Sheet: /
File: 5v_psu_oscillator.sch

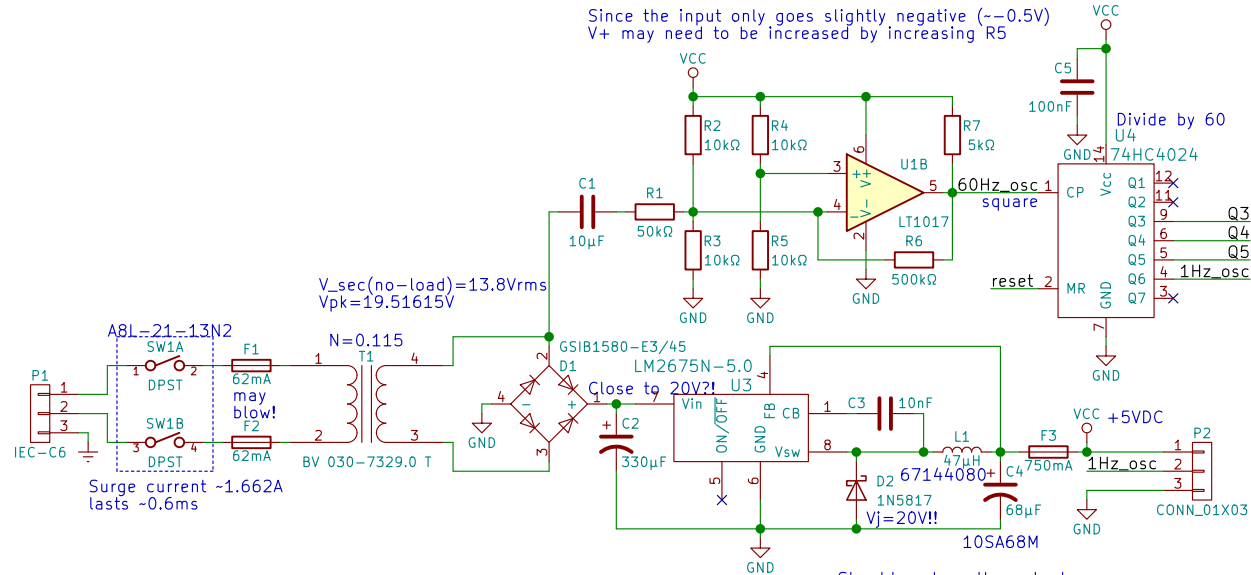
tie digital GND to chassis/earth GND through mounting holes/screws

Since the input only goes slightly negative ($\sim -0.5V$) V_+ may need to be increased by increasing R_5

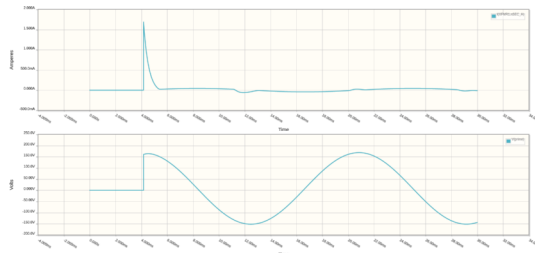
Should replace the output cap with one rated to $\sim 26V$ in case of failure mode where output can accidentally reach the input voltage Sanyo MV-GX 150μF @ 35V (PN ??)
